Enclosure (1) is the Final Parcel E Nonstandard Data Gaps Investigation Landfill Lateral Extent Evaluation. This report is provided for your information.

Enclosure: 1. Final Parcel E Nonstandard Data Gaps Investigation Landfill Lateral Extent Evaluation, Hunters Point Shipyard, October 29, 2004

This document discusses data collected for, and results of, an investigation to assess the extent of solid waste at the Industrial Landfill in Installation Restoration Site 01/21 of Parcel E (hereinafter referred to as the Landfill) at Hunters Point Shipyard (HPS) in San Francisco, California. This work was conducted as part of the Parcel E nonstandard data gaps investigation under the protocols set forth in the "Draft Final Field Sampling Plan and Quality Assurance Project Plan [FSP/QAPP] for Parcel E Nonstandard Data Gaps Investigation (Industrial Landfill and Wetlands Delineation), HPS, San Francisco, California," dated January 8, 2002. This report is part of the revised remedial investigation and feasibility study for the Landfill at HPS. The results from this evaluation will be used to assist in development of the final remedy for the Landfill.

**FIGURE 1
 FACILITY LOCATION MAP**

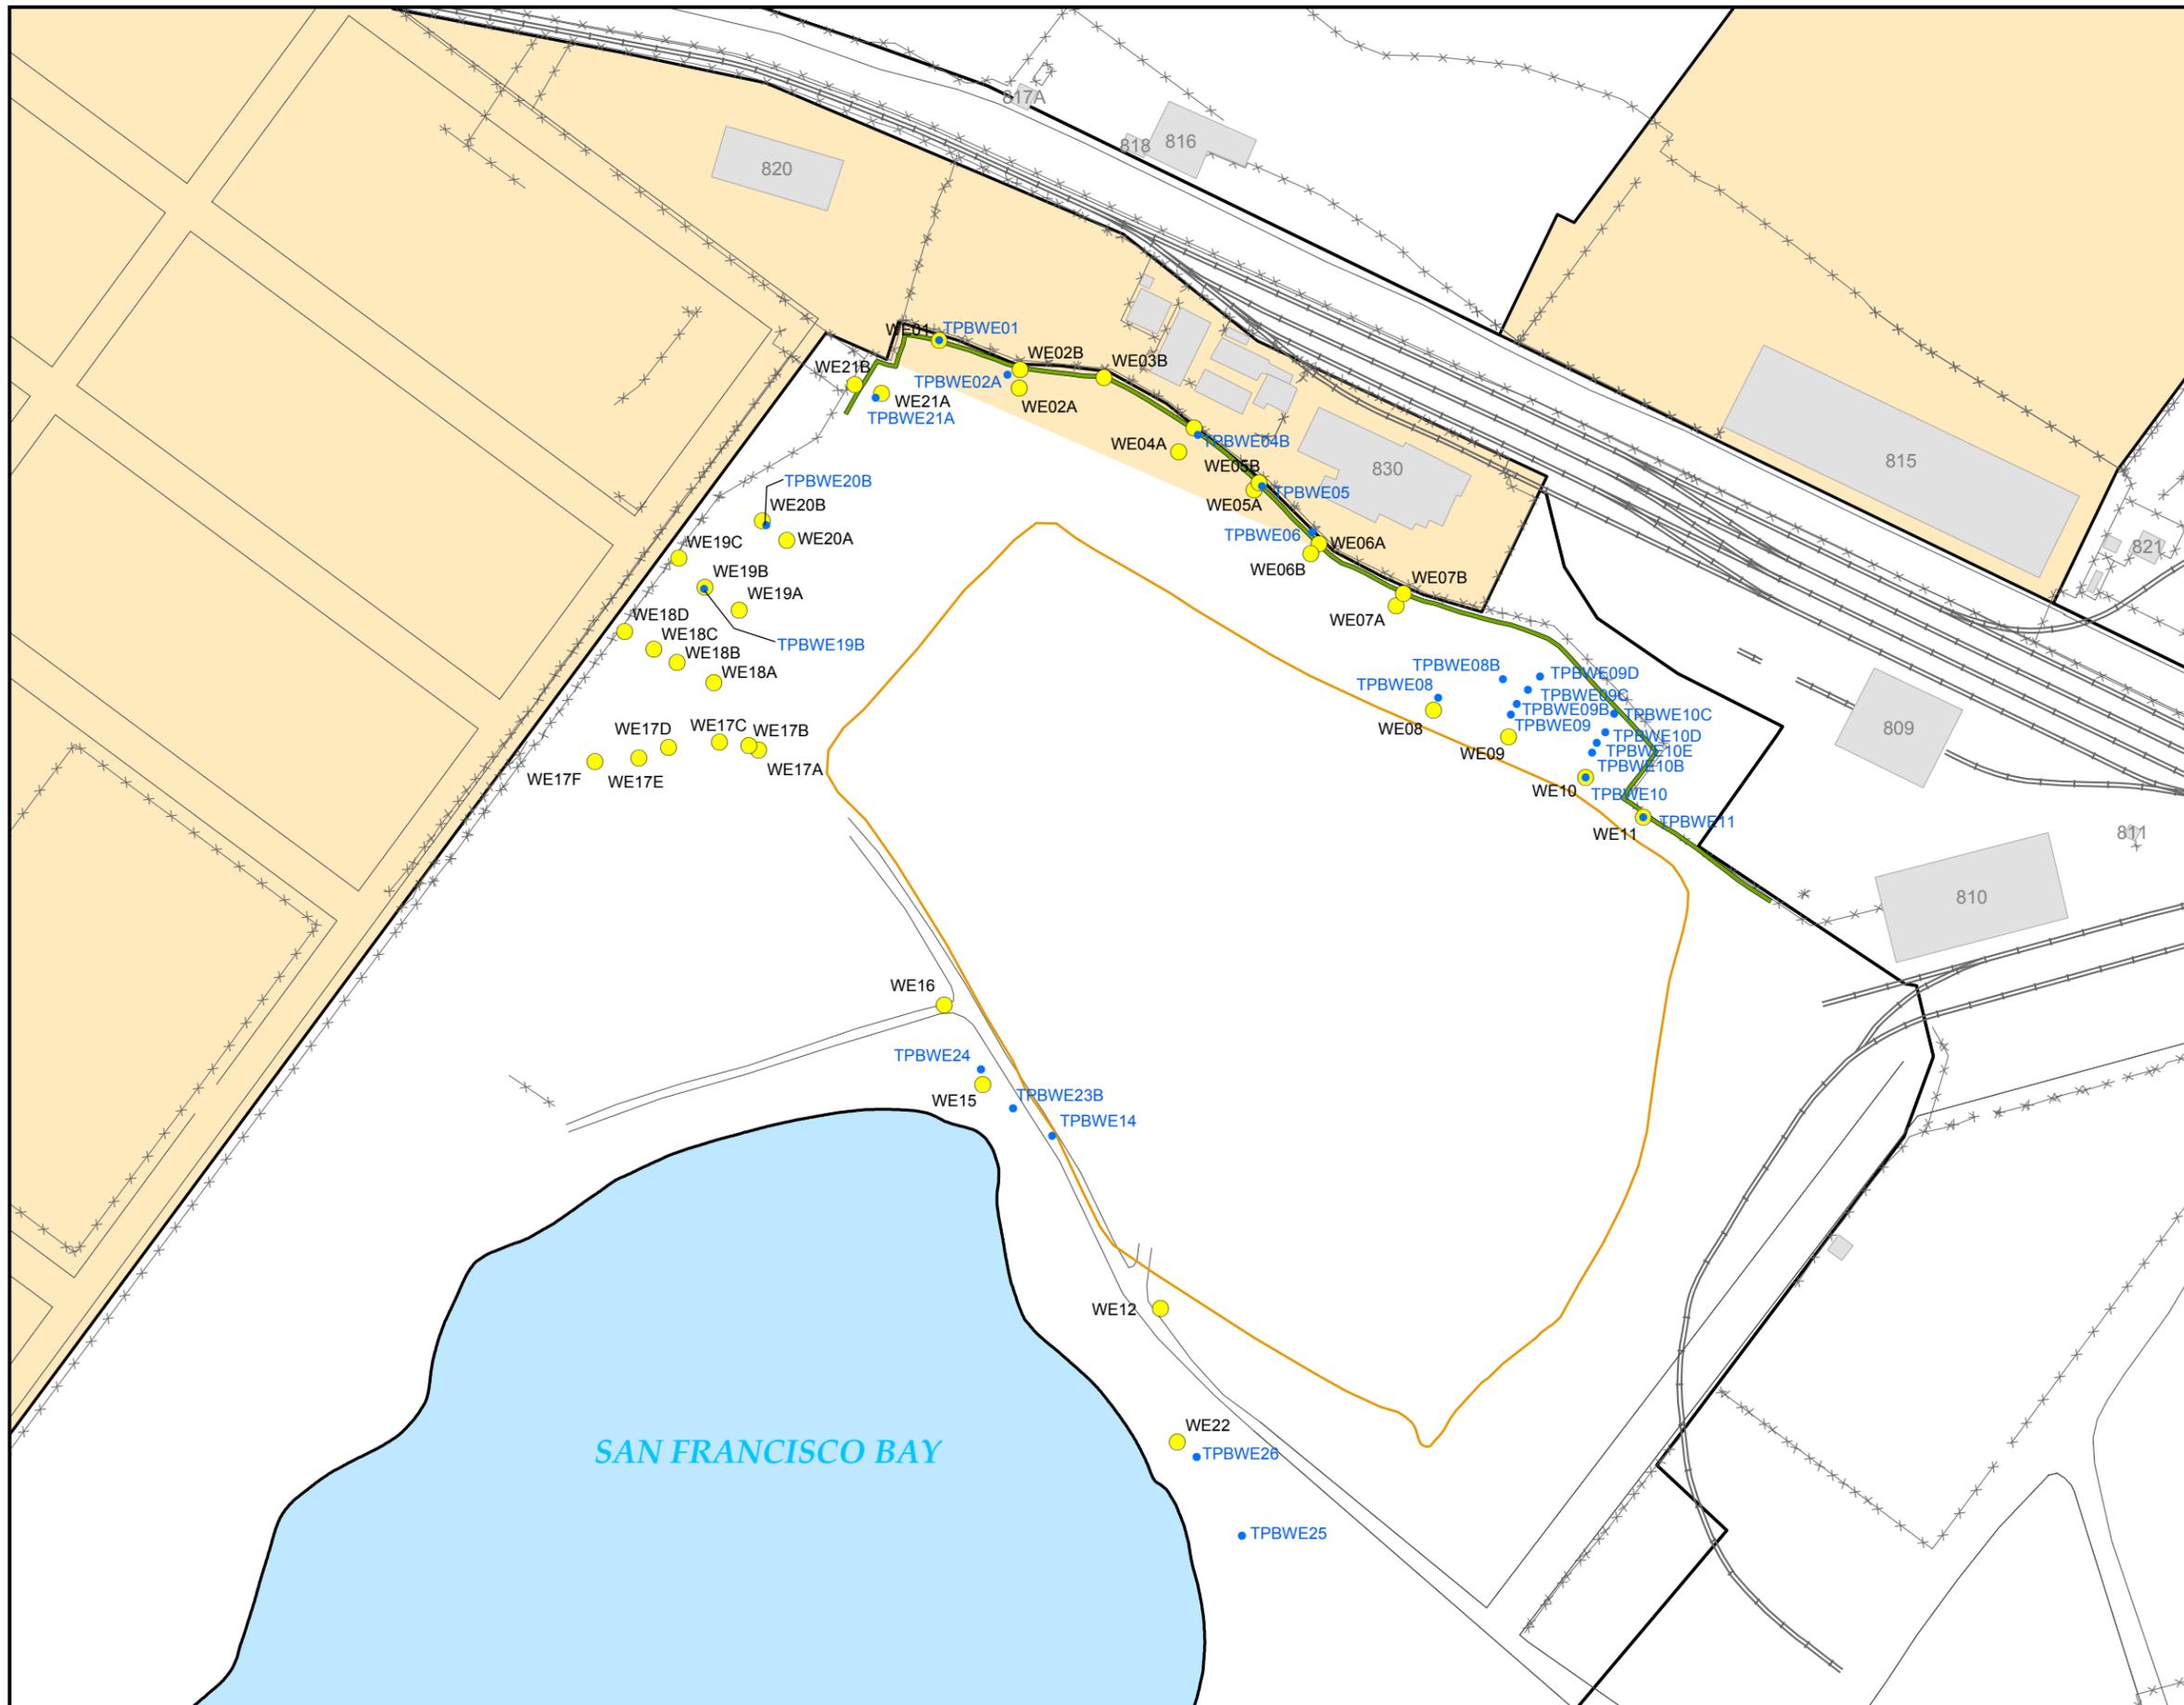
Figures 1, 2, and 4. UCSF property extends to the Hunters Point property boundary. Please revise figures and text accordingly.

[Figures 1, 2, and 4](#) correctly show the property boundary between HPS and the University of California at San Francisco property.

**FIGURE 2
 TEST PIT AND SOIL BORING
 LOCATIONS**

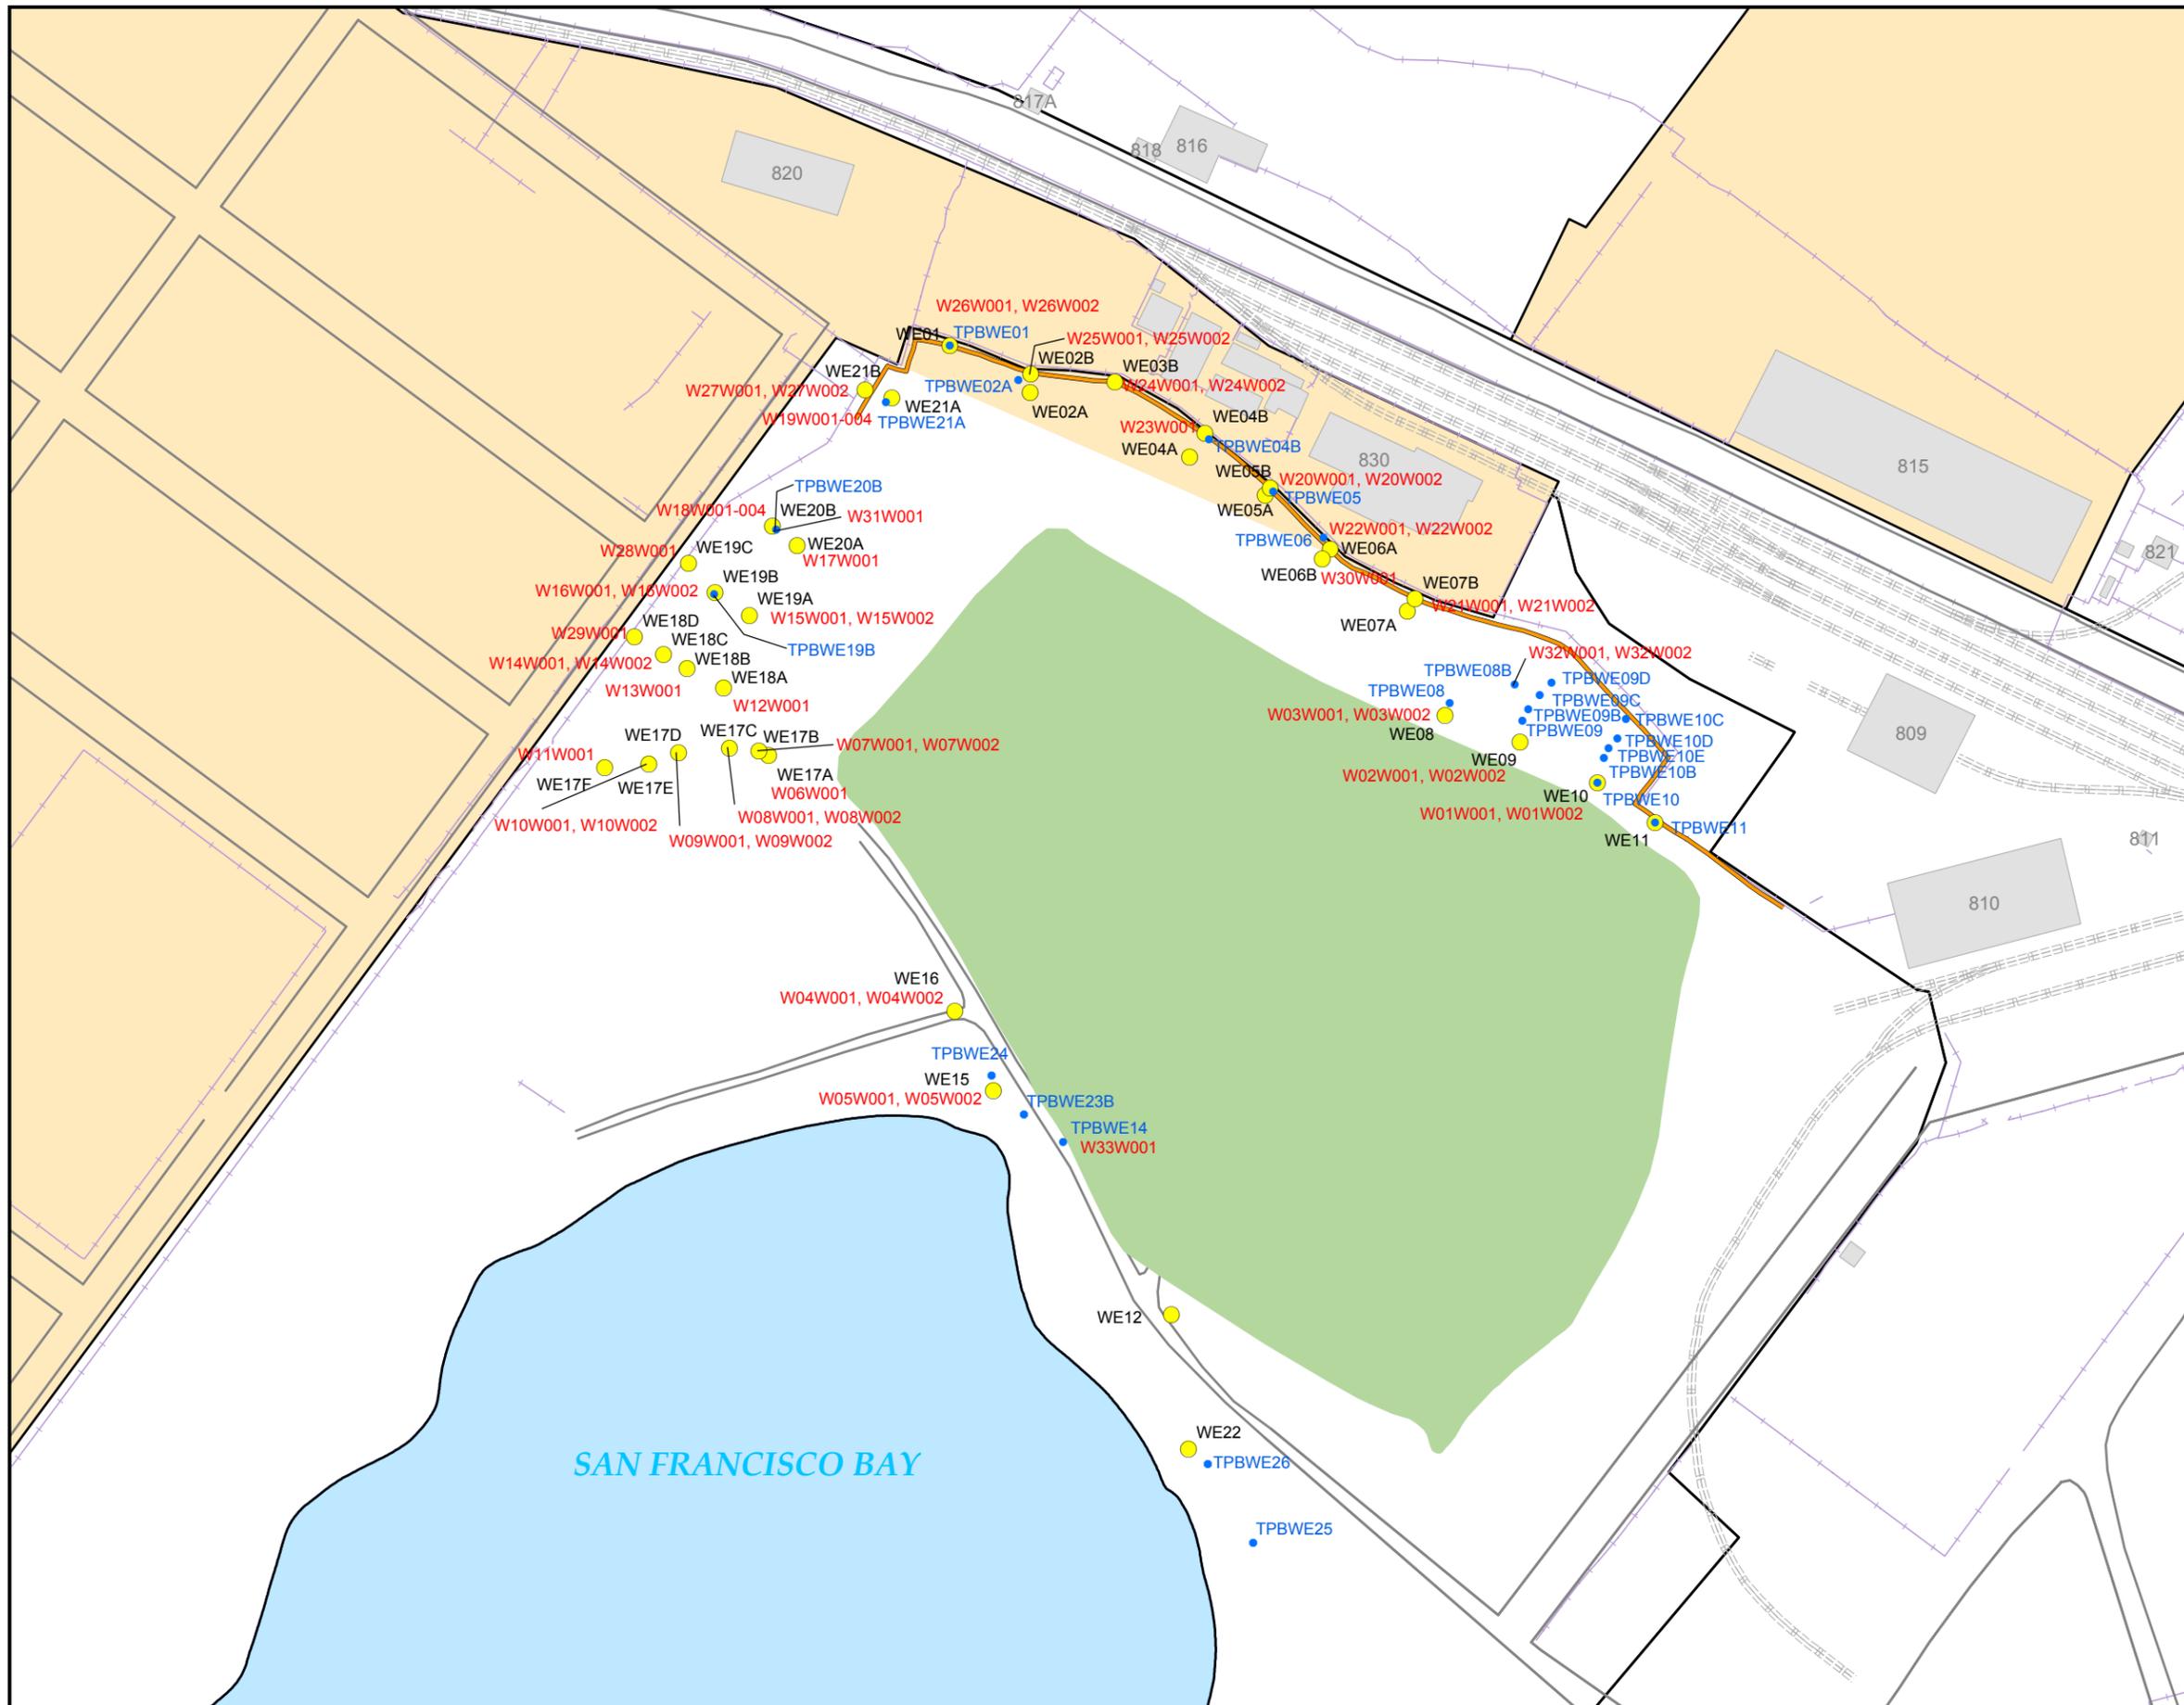
Errors. The log is titled "TPBWE05" but Figure 2 shows the location as "TPBWE05-2". And, the log says "TPBWE06", but Figure 2 says "TPBWE06A ". Similarly, should "WE05" on Figure 2 be changed to "WE05-1"?

On [Figure 4](#), borings TPBWE05A and TPBWE06A have been revised to borings TPBWE05 and TPBWE06. On [Figures 2, 3, and 5](#), borings TPBWE05-2 and TPBWE06A have been revised to borings TPBWE05 and TPBWE06. On [Figures 2 through 5](#), borings WE05 and WE05-2 have
